Architectural Review Board

Staff Report (ID # 7445)

Summary Title: 240 Pasteur Drive - Biomedical Innovations Building

Title: PUBLIC HEARING / QUASI-JUDICIAL MATTER. 240 Pasteur Drive [16PLN-00362]: Recommendation to the Director of Planning and Community Environment for a Requested Approval of an Architectural Review Application to Allow the Construction of the a new Biomedical Innovations Building for the Stanford University School of Medicine. The Approximately 215,000 Square Foot Building was Previously Entitled in 2011. The Proposed Project Includes Architectural Modifications to Reflect Updated Internal Program Needs, Surrounding Pathways, Heritage Trees, and the Architecture of the Adjacent Hospital. Environmental Assessment: An Environmental Impact Report was Previously Certified for This Project Pursuant to the California Environmental Quality Act (CEQA). Zoning District: HD

Approved FIM 1 Tree Removal and Relocation, March 17, 2011:

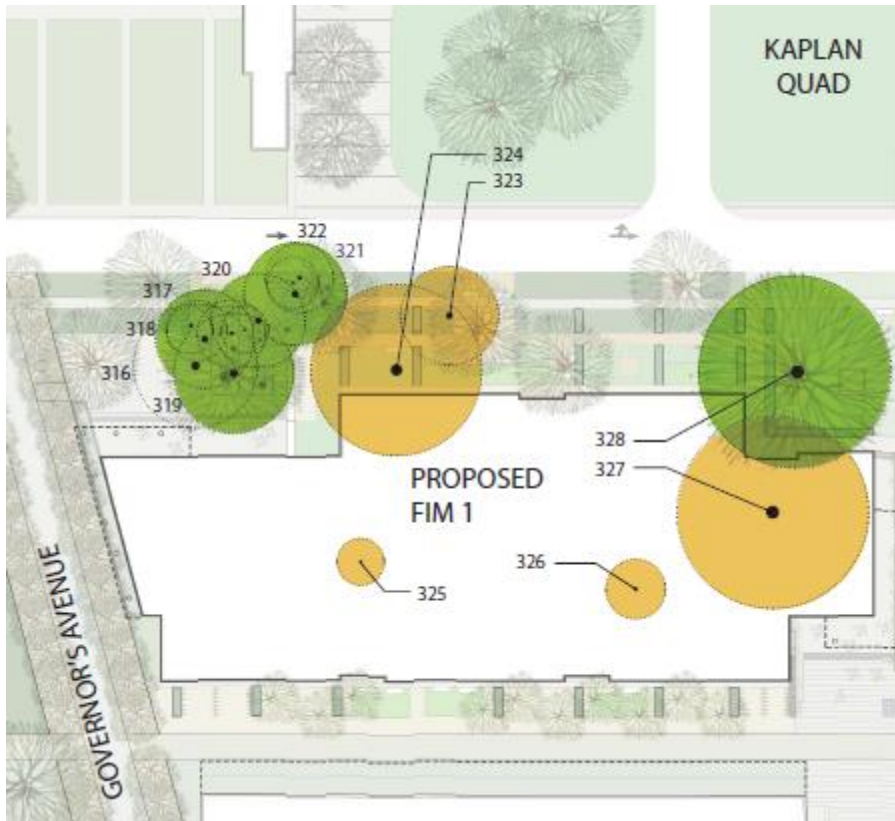
The former Group 2 Tree #325 was removed and relocated consistent with standard City and SUMC review. Consistent with the prior FIM 1 approval, the updated site design for the BMI building still proposes to remove two Group 2 trees (326 and 327), as well as relocate two Group 1 trees (323 and 324) to another location in the vicinity. The remaining oaks would be retained in place. The applicant adjusted landscaping, hardscape, and utility designs to offer additional tree protection for the Group 1 trees in post-project conditions. Stormwater management is proposed on the east side of the BIM building. Urban Forestry, Public Works, Utilities, Green Building, and Planning staff are still analyzing the updated design.
